Item 3.**Development Application: 45 Renwick Street, Alexandria - D/2022/592**

File No.: D/2022/592

Summary Recommendation: This proposal is recommended for refusal.

Figure 5: Proposed Roof Plan demonstrating the proposed rooftop terrace, swimming pool and laneway structure

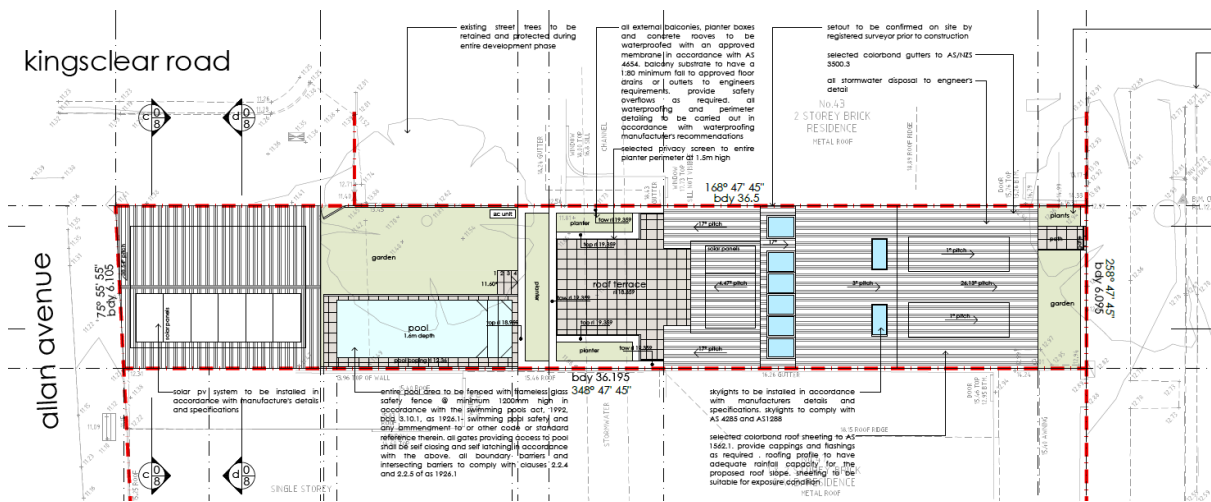
37. As per Provision 4.1.8 of the DCP, first floor balconies and rooftop terraces are to be avoided at the rear and side of a dwelling. The proposed 18sqm rooftop terrace accessible from the third level at the rear of the site would result in significant visual privacy and amenity impacts to Nos 49, 47, 43 and 41 Renwick Street and No. 91 Kingsclear Road.

40. For the reasons outlined above, the rooftop terrace and first floor rear balcony are considered to detract from the design quality of the building and are not supported.

Figure 7: Proposed first floor plan demonstrating the large internal void at the centre and rear balcony

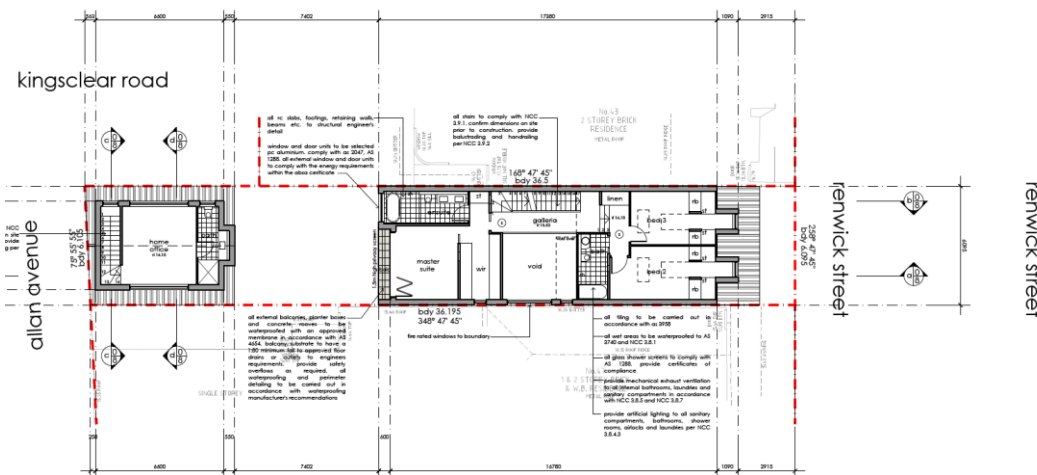
30. The first floor rear setback does not comply with Provision 4.1.2 of the DCP. The first floor rear building line is inconsistent with the predominate building line established by Nos. 39-43 Renwick Street, exceeding this by 1.8m and resulting in additional overshadowing and amenity impacts to No. 43.
31. The proposed internal layout, including the large void (Figure 14 below) 12 sqm in area between the ground and first floors does not demonstrate good design and contributes to the excessive bulk of the dwelling whilst relying on borrowed amenity from No. 43 through proposed boundary windows on the western elevation.

39. First floor rear balconies are to be avoided under provision 4.1.8 of the DCP. The proposed first floor balcony is 19 square metres in area and extends across the width of the rear elevation. The height and expansive area would likely result in visual privacy and amenity impacts to neighbouring sites and is not required in order to provide adequate private open space to the subject dwelling.

Figure 8: Proposed second floor plan demonstrating the 18sqm rooftop terrace

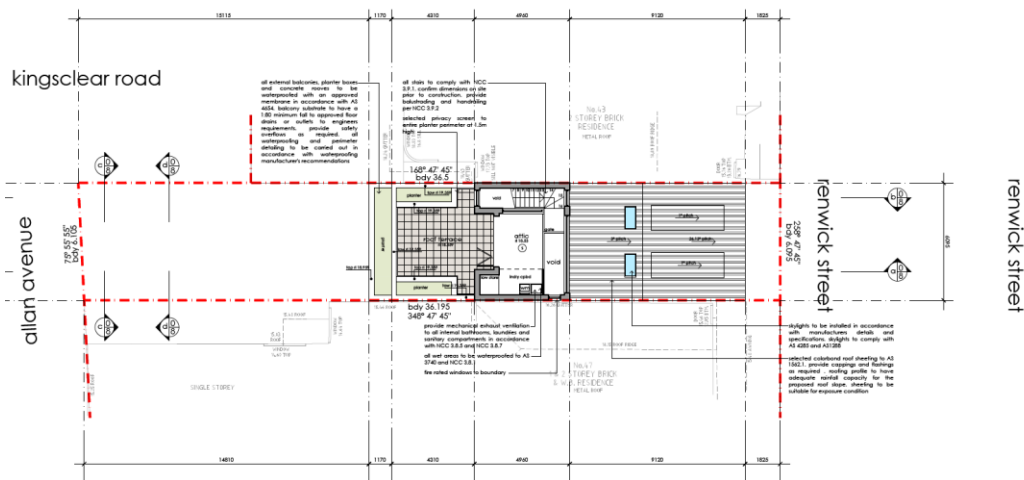
38. Whilst the terrace includes planters around the perimeter of the space, these will only support small plantings and will not provide adequate privacy and noise mitigation.

Figure 9: Proposed north elevation (main dwelling) showing the first floor balcony and rooftop terrace

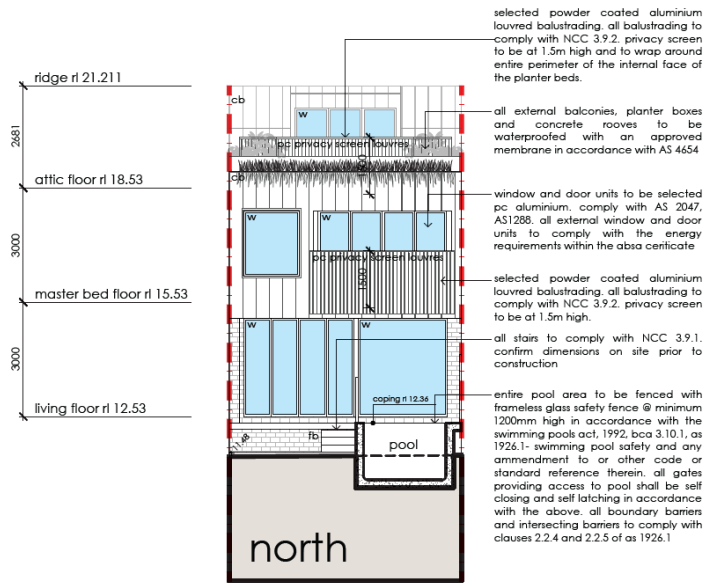
36. The proposal would result in significant visual privacy issues to neighbouring sites as a result of the proposed rooftop terrace and first floor rear balcony.

Figure 10: Proposed south elevation (Renwick Street) showing the proposed bulk and scale compared to neighbouring dwellings

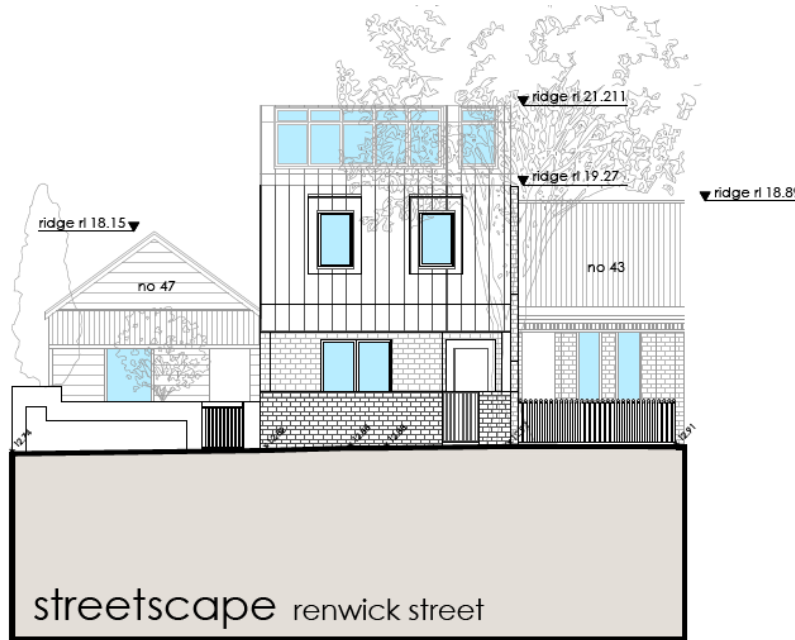
23. The three storey presentation to the street results in an overbearing and inconsistent built form with existing dwellings within Renwick Street and results in several amenity impacts to neighbouring sites.

- As noted above, the proposal presents as a three storey building at the street interface, providing an inconsistent presentation to Renwick Street.
26. The development therefore fails to satisfy design excellence provisions.

Figure 11: Proposed west elevation demonstrating the extent of the three storey dwelling and several side boundary windows

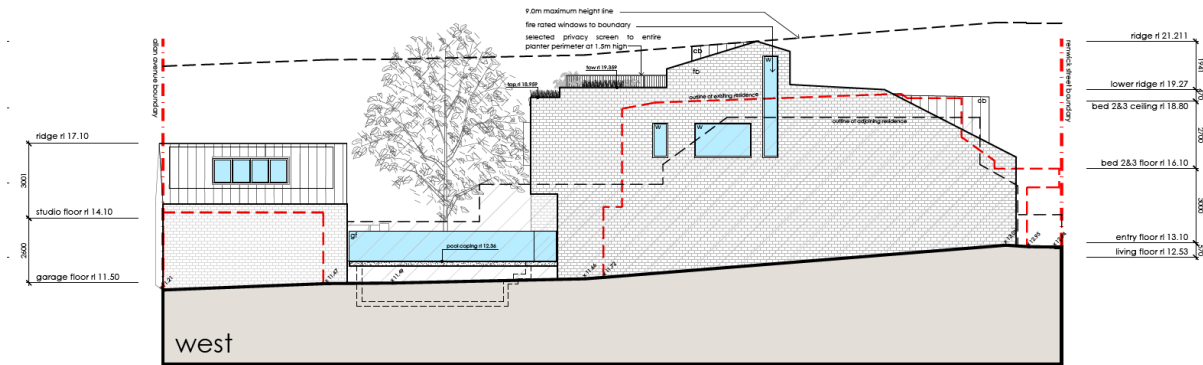
- The proposed side boundary windows on the western elevation rely on borrowing amenity from No. 47 including solar access, ventilation and outlook and are not supported.

41. The proposal includes three (3) large windows on the first and second floors of the western elevation. The windows are located on the boundary with No. 47 Renwick Street which is currently single storey in nature. The windows would provide light to the proposed internal void and first floor walk in wardrobe. The windows rely on borrowed amenity from the neighbouring site at No. 47 Renwick Street and are not supported. The positioning of the windows on the boundary would also unfairly impact any future development at No. 47 which is permissible to have a first floor rear addition.
42. The requirement to have side boundary windows is not considered necessary as it would predominantly support the internal void which in itself is not supported as discussed under the above subheading 'Bulk and Scale'.

Figure 12: Proposed east elevation demonstrating outline comparison with the existing neighbouring dwelling

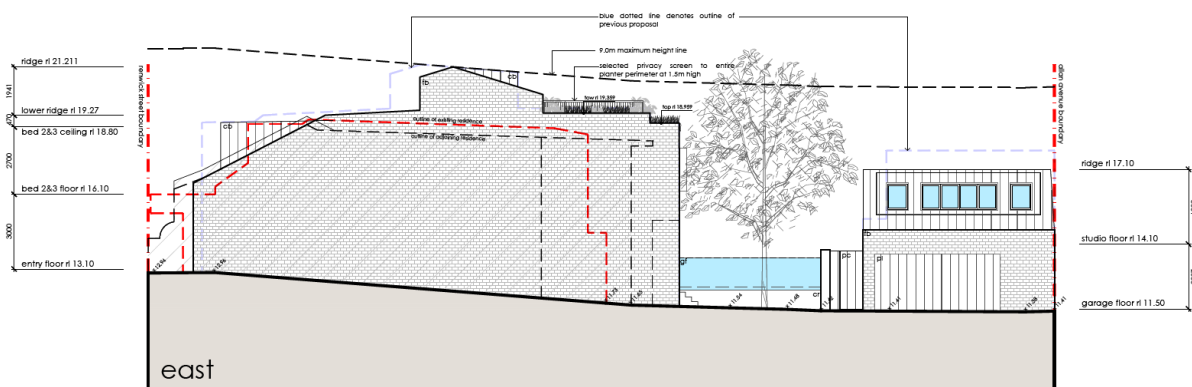
- The silhouette of the proposed development does not respond to the neighbouring built form at No. 69-73 Renwick Street or the existing dwelling.

Figure 13: The silhouette of the original and amended proposal does not respond to the neighbouring properties at 69-73 Renwick Street or the existing building being replaced.

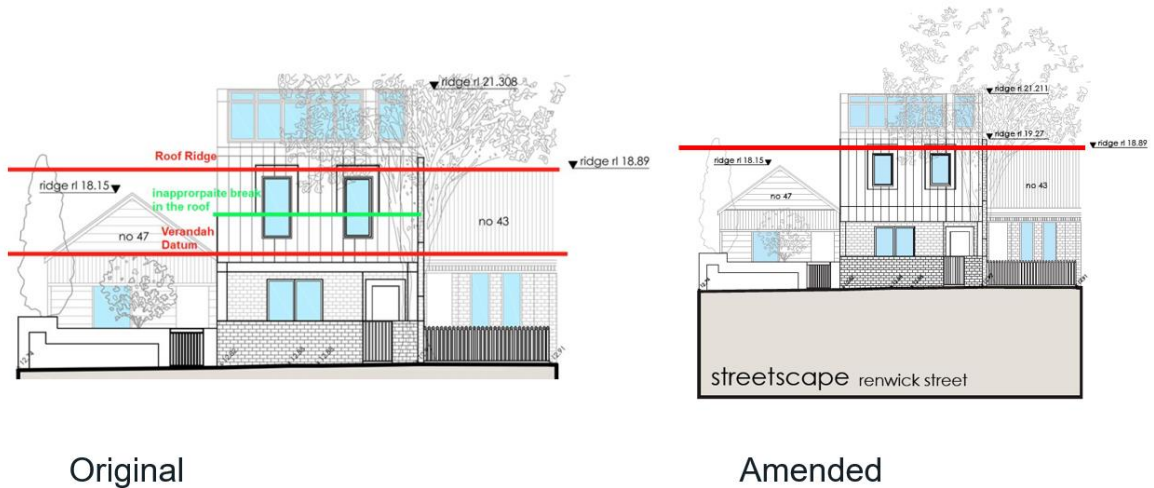
29. The proposed mansard roof form, height (overall ridge height and the lack of reference to the datum line established by the verandah), bulk, and detailing (including the use of exposed steel column framing the ground floor) are unsympathetic to the neighbouring contributory buildings. Figure 13 below demonstrates the original proposal and updated proposal, showing changes to the front dormer windows allowing for a consistent roof break and a minor decrease in height. However, issues remain resulting in a built form and presentation to the street that is inconsistent with neighbouring dwellings and the objectives of the heritage conservation area.

- The proposed design fails to take cues from neighbouring dwellings by aligning the main roof ridge with that of the unmodified neighbouring terrace to provide a unified and modern infill development within the established conservation area.

Figure 14: Proposed first floor plan showing large void (red outline) in the centre of the building.

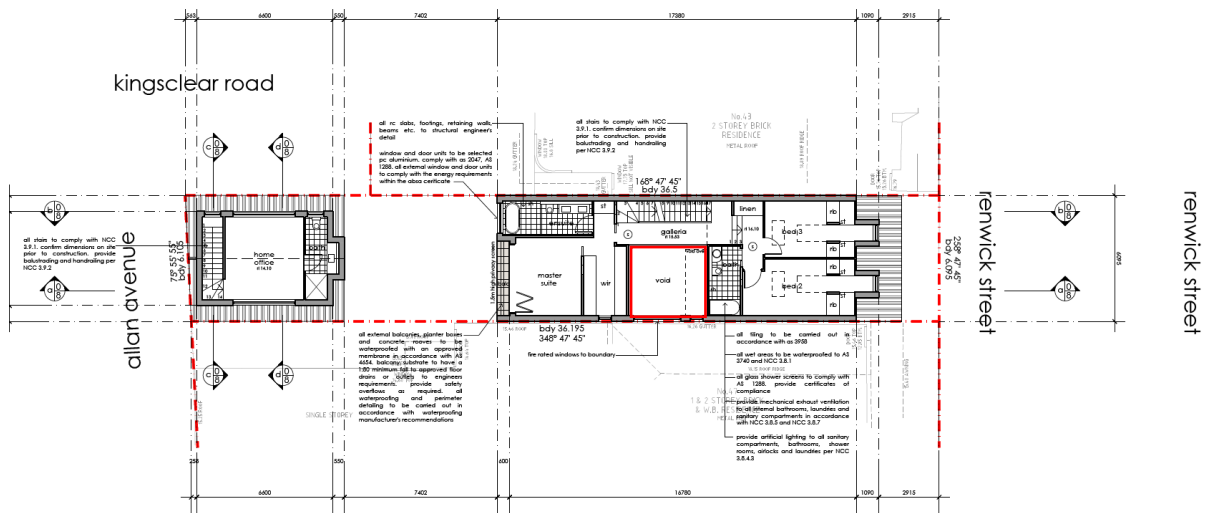
- The large internal void area also contributes to significant additional bulk. While the intent to maximise natural light to the middle of the terrace is positive, alternative designs which do not rely solely on amenity provided outside the property boundary, such as reducing the depth of the floor plate and providing additional skylights should be explored.
